# MEMORANDUM

Re: Whitewater Middle School Site Plan Review

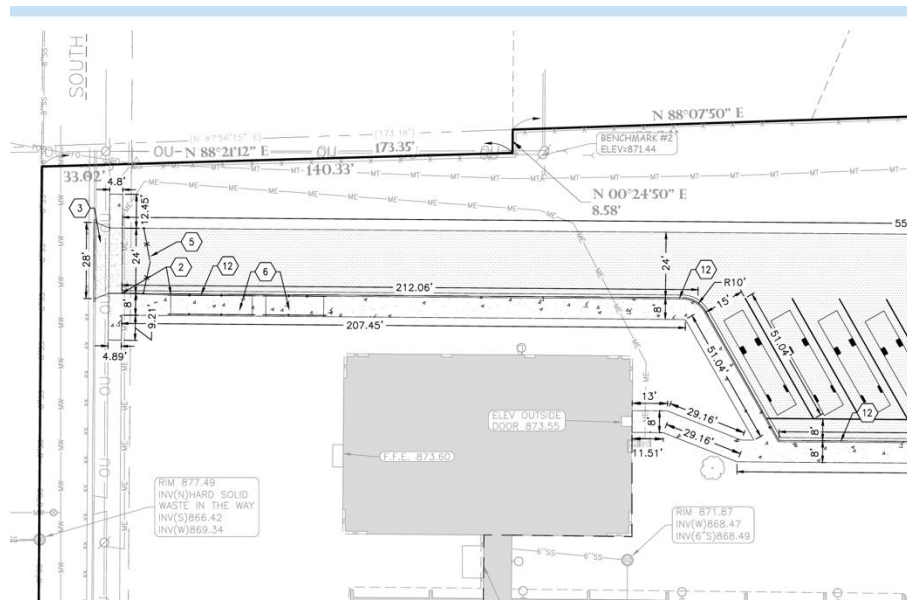
**The proposed off-street parking additions meet the minimum required 15' street yard setback requirement. Sheet C2.1 does not provide a side yard setback dimension between the closest point of the driveway addition near S. Elizabeth Street and the property line shared with the neighboring residential property (See below). An updated site plan that provides a side yard setback dimension is desirable.**

- 1) Staff recommends to **APPROVE** the site plan for parking lot additions at 401 S. Elizabeth Street / WUP 00215 & /WUP 00216 with the following conditions:
  - a. All lighting shall comply with the City of Whitewater Ordinances.
  - b. All zoning and building permits for construction be properly obtained.
  - c. Update sheet C2.1 to indicate side yard setback dimension.
  - d. Landscaping shall be completed to the specifications of the site plan in accordance with City of Whitewater landscaping guidelines. Any deviation from the site plan shall require additional staff approval.
  - e. All Engineering comments shall be addressed prior to construction starting.
  - f. Site plan shall not deviate from approved plans. Any deviation shall require additional staff approval.
